in the matter of: an application by Carter Group Limited in relation to
the Ryans Road Industrial Development

Memorandum of counsel for Carter Group Limited regarding
amendments and additional information

Dated: 15 August 2025

Erosion & Sediment Control Plans – EW205 - 207

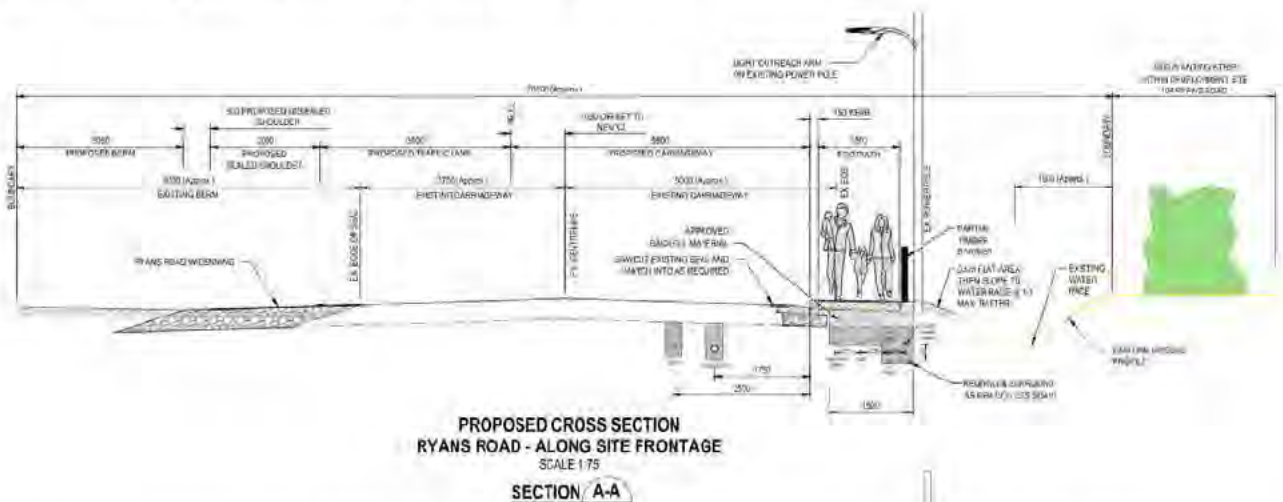
- Reduction in the clothed line temporary diversion channel along Ryans Road because the existing water race is to be retained and only piped where required for road intersections and vehicle crossings. Retaining the water race was requested by CCC, ECAN and SDC.
- Temporary diversion of the water race is still required in the culvert installation areas and is to be undertaken in accordance with Auckland Council Guideline Document 2016/005 Section G4.0.

Ryans Road Upgrade (revised Typical Cross Section)

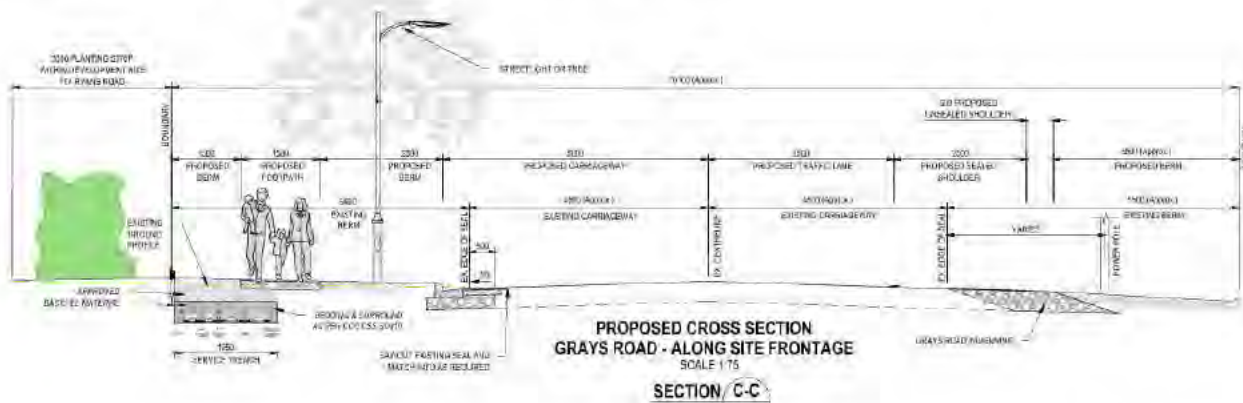
- Increased widening through intersections (two proposed and existing Grays) to accommodate channelised Right Turn Bays.
- Proposed centreline offsite 1m to the south to accommodate wider 5.5m carriageway on northern side, including footpath and retaining existing water race along frontage.
- Location of kerb and footpath moved south to provide flat area at back of footpath and tie into the existing ground levels without impacting the water race.
- Partial timber barrier provided at back of footpath for pedestrian barrier to water race.
- Extra widening on western side for increased carriageway width and wider sealed shoulder.
- Indicative vehicle crossings for Lots 55 to 60 and 400 proposed off Ryans Road with culverts through water race.

The amendments to Ryans Road design provide for better transportation and ecology outcomes for the development.

Figure 1: Proposed catchment delineation (background layout plan courtesy of 'Capture Land Development Consultants')

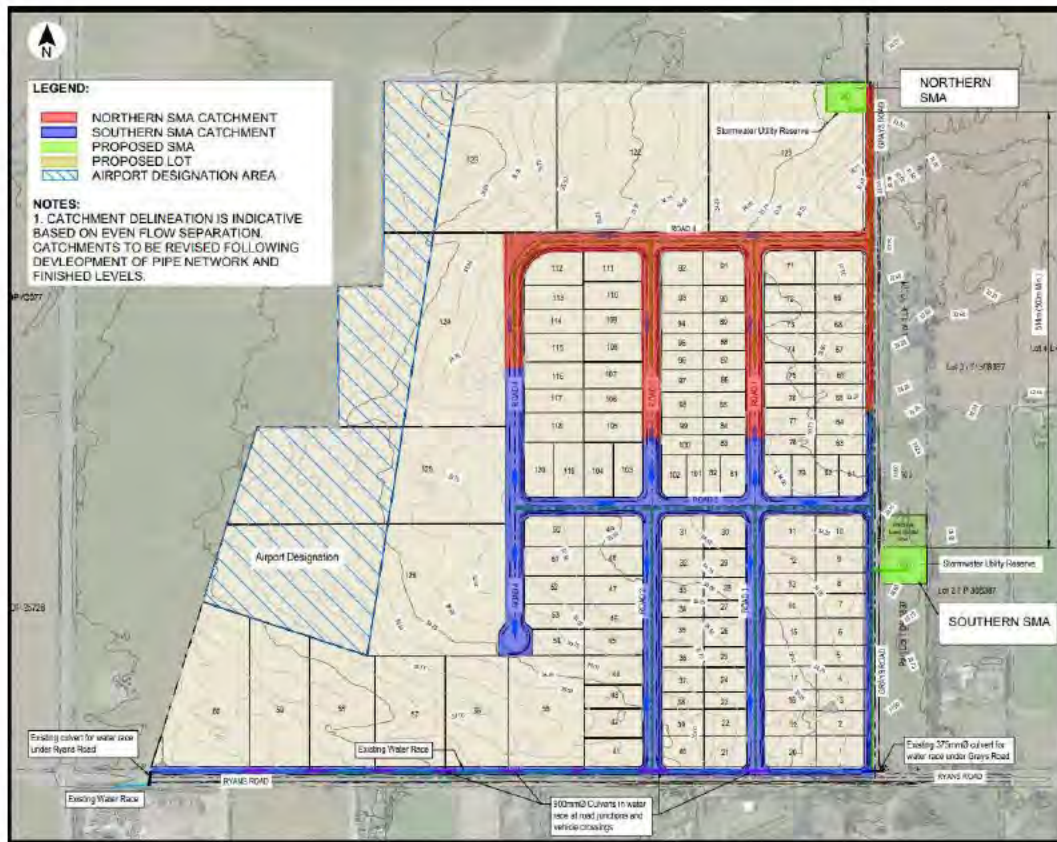
As discussed in the 'Stormwater Management Technical Assessment' previously completed by PDP, stormwater is to be collected from the road reserve via a network of kerb and channel, sumps and pipework which discharge to two SMA's. Figure 1 below shows the proposed catchment areas for each SMA. Following relocation of SMA's to achieve minimum 500 m separation, contributing catchment areas and run-off have not changed from previously delineated. In line with the previous design, each SMA will include an infiltration basin and overflow soak pit.

Assuming the catchments as illustrated in Figure 1 above and design parameters outlined in Section 3.4 of the 'Stormwater Management Technical Assessment' previously prepared by PDP, sizing of the proposed infiltration basins and overflow soak pits has been revised to ensure maximum water surface area during the 50-year critical duration storm does not exceed 1000 m².

DRAWING TITLE
CIAL RUNWAY APPROACH
PROTECTION SURFACES

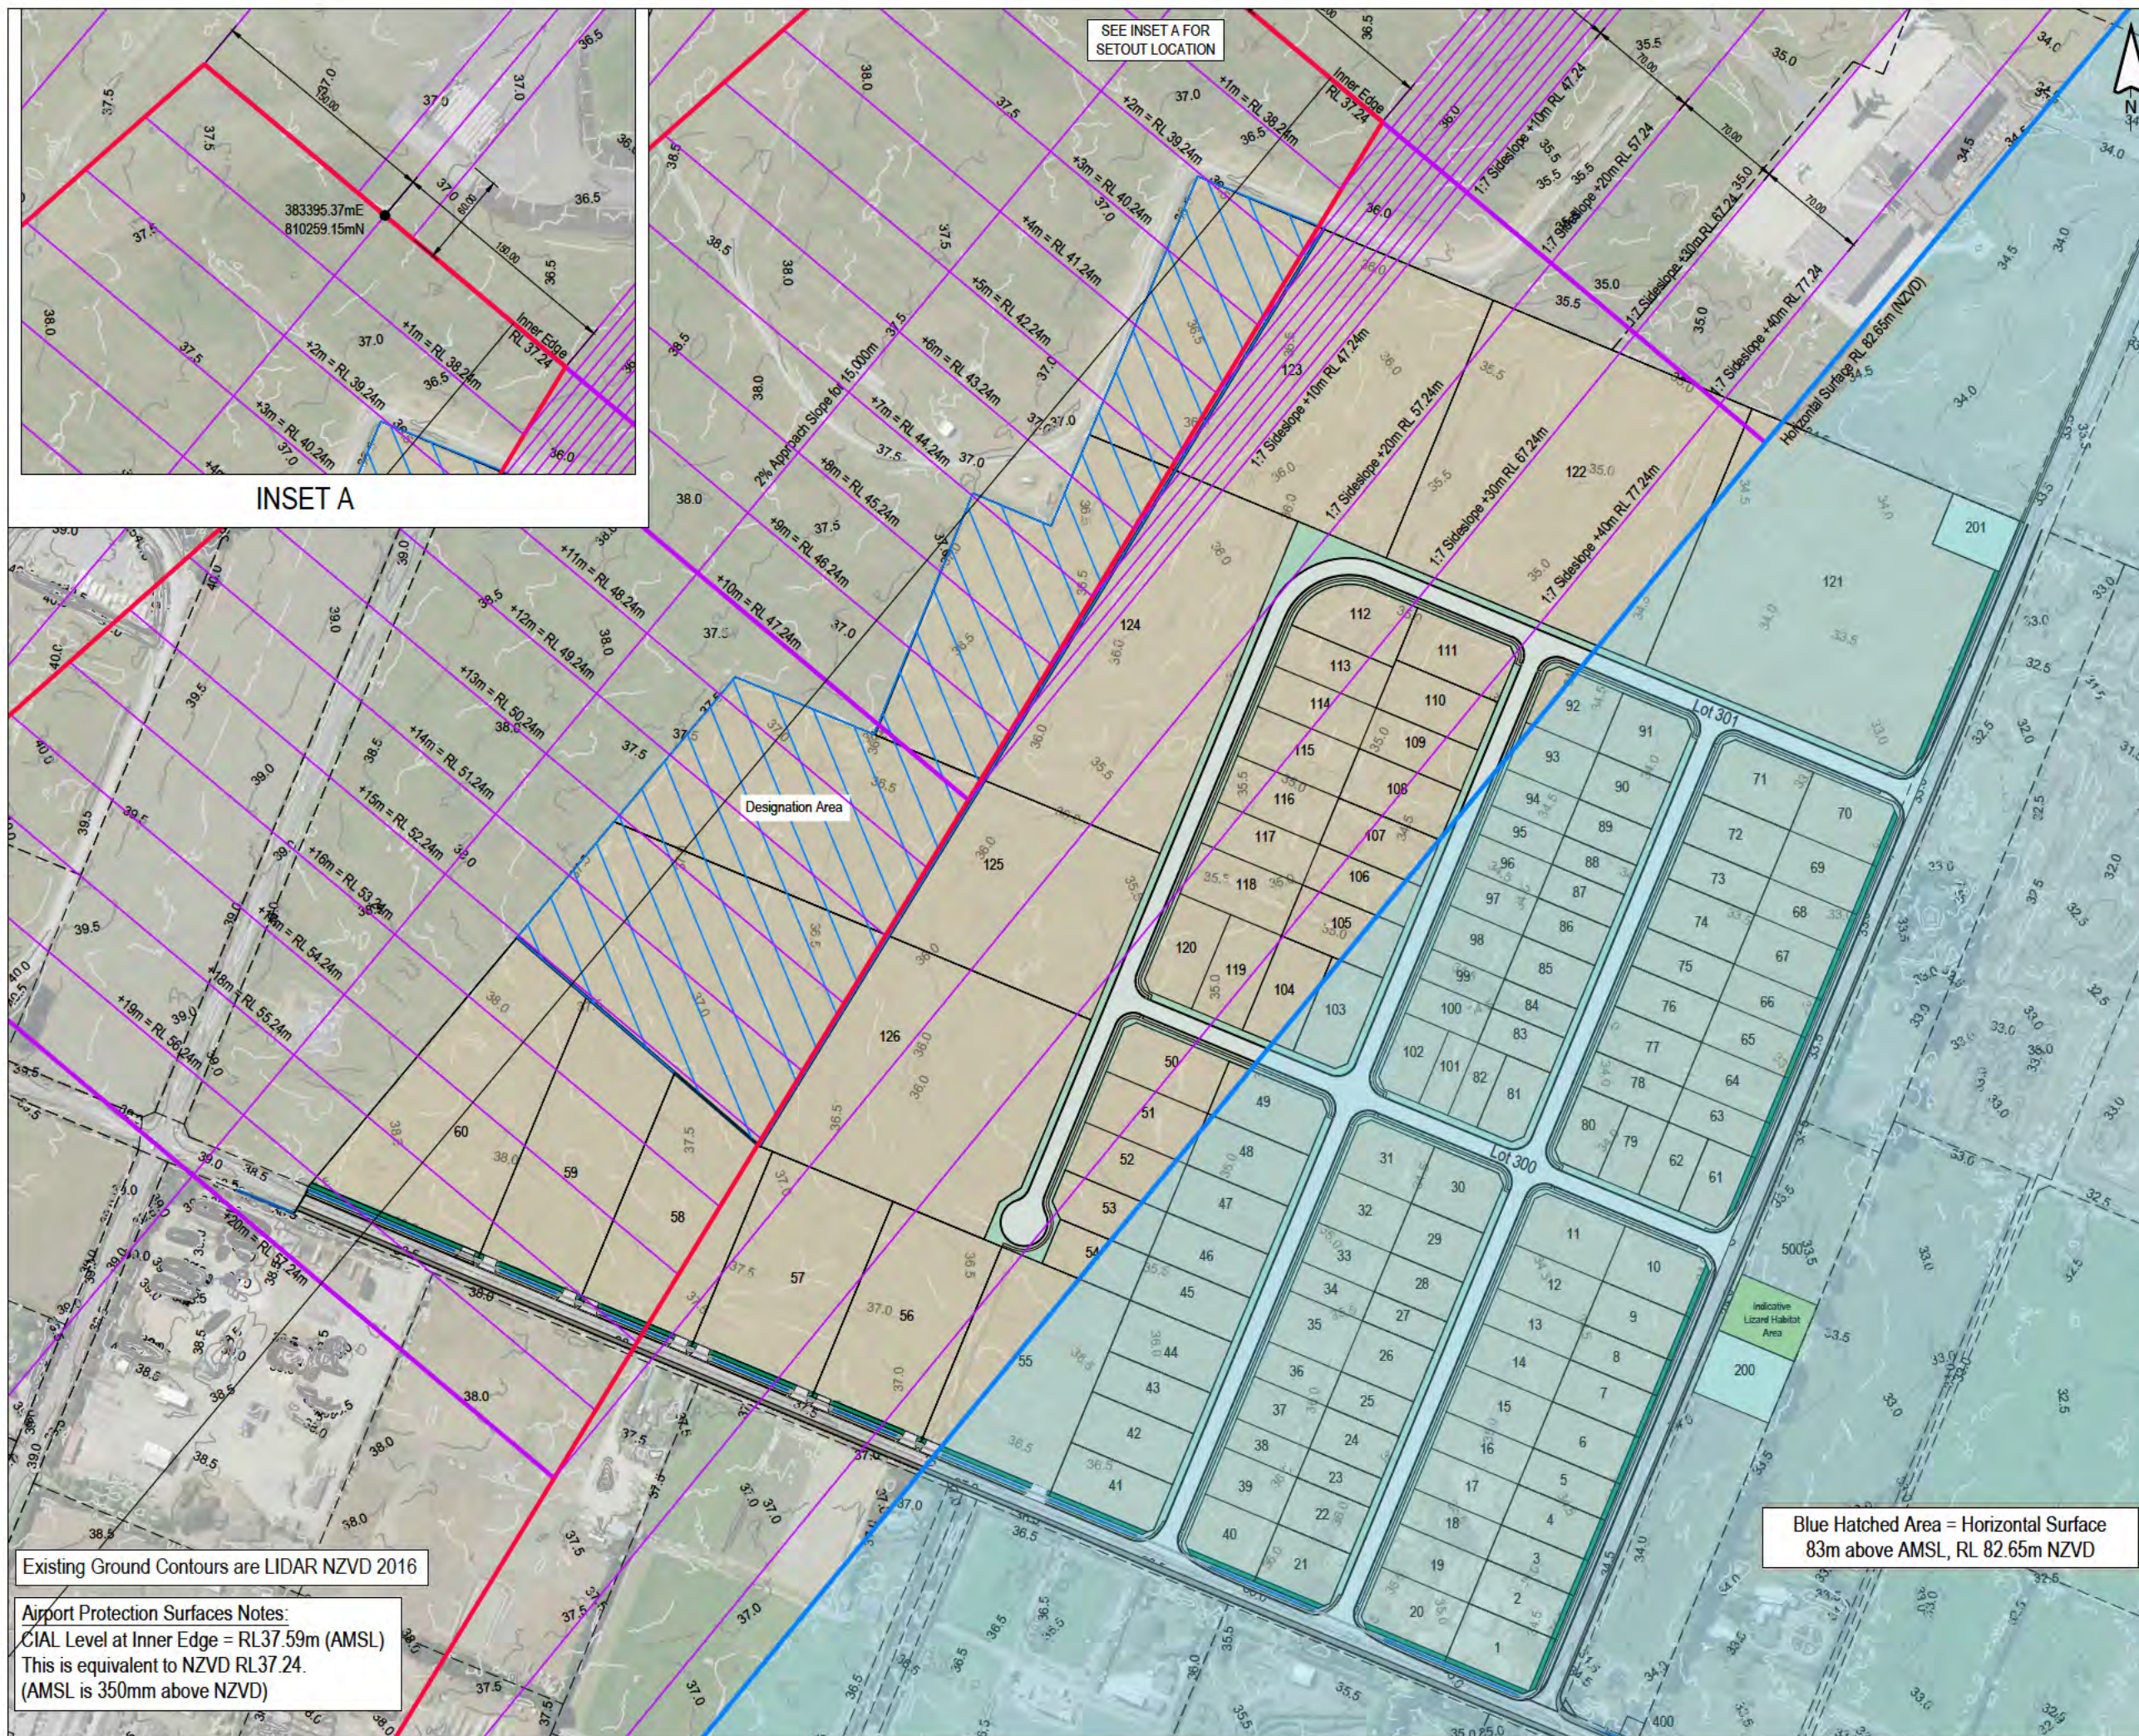
REV	DATE	REVISION DETAILS	ISSUED
A	25/02/25	FOR APPROVAL	TL
B	05/08/25	HORIZ SURFACE ADDED	TL
C	07/08/25	MINOR REVISIONS	TL
D	12/08/25	MINOR REVISIONS	TL

DRAWING TITLE
WINDSHEAR & TURBULENCE ASSESSMENT AREA

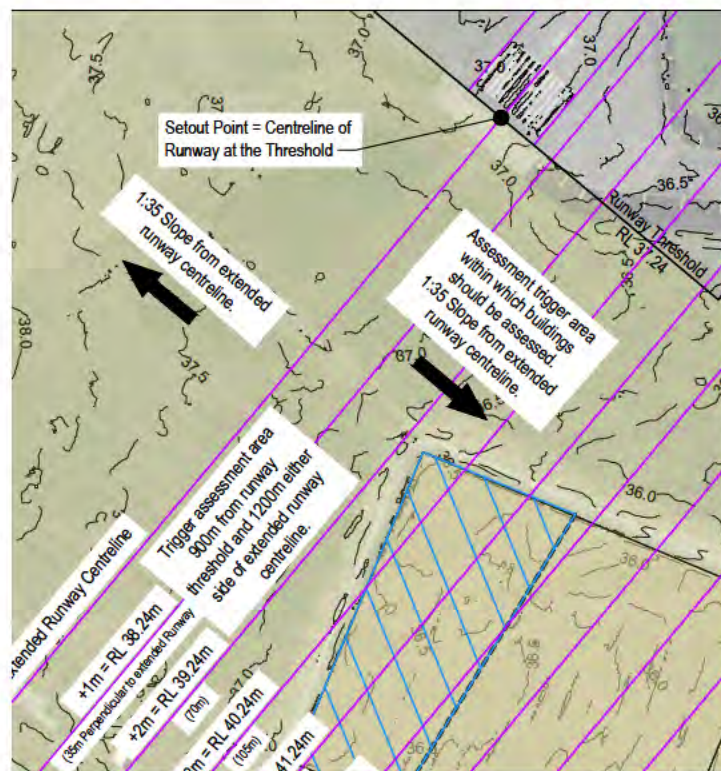
F. BGWS trigger plane (RC-PG126)

No building, structure, or utility shall penetrate the BGWS trigger plane shown on RC-PG126 unless certified under Condition 5G.
